**PREVOST**

**WARRANTY  
BULLETIN**

**WB18-15**

| SUBJECT :   | <b>MID140 INSTRUMENTS CLUSTER<br/>SOFTWARE UPDATE</b> |           |                |

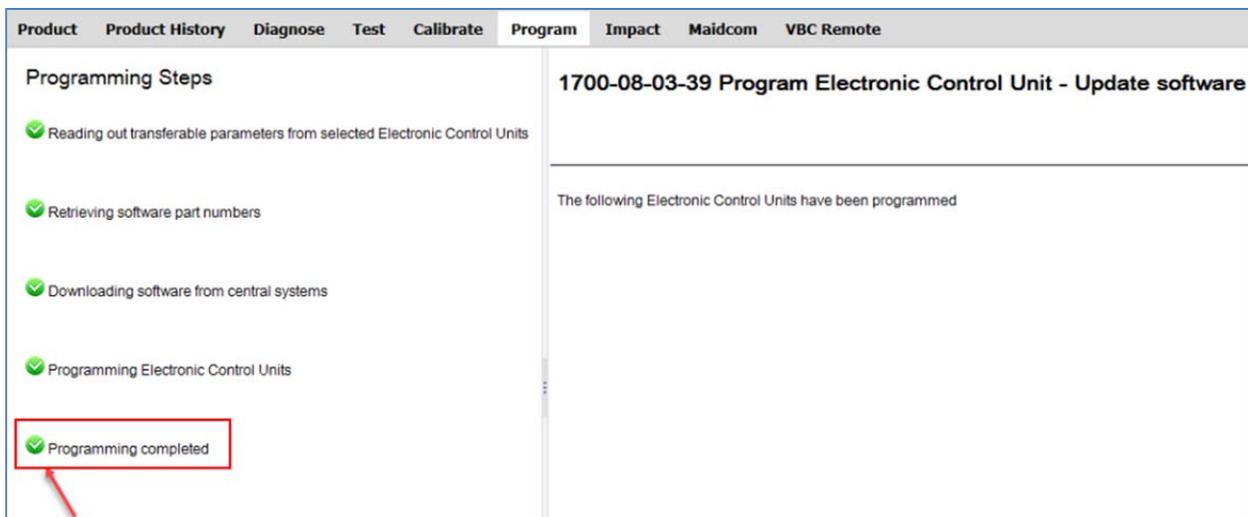
On the vehicles affected by this bulletin, the instrument cluster software must be updated. This mandatory cluster software update will raise the primary and secondary air system “low pressure warning” set point.

Make an appointment at the nearest Prevest Service Center or Service Provider to have bulletin WB18-15 performed free of charge or using **Premium Tech Tool**, reprogram MID140 to the latest update available.

1. Using Premium Tech Tool, reprogram the instrument cluster (MID140) with the latest update available.
2. Confirm completion of the instruments cluster programming with the *Program > Update Software* screen.
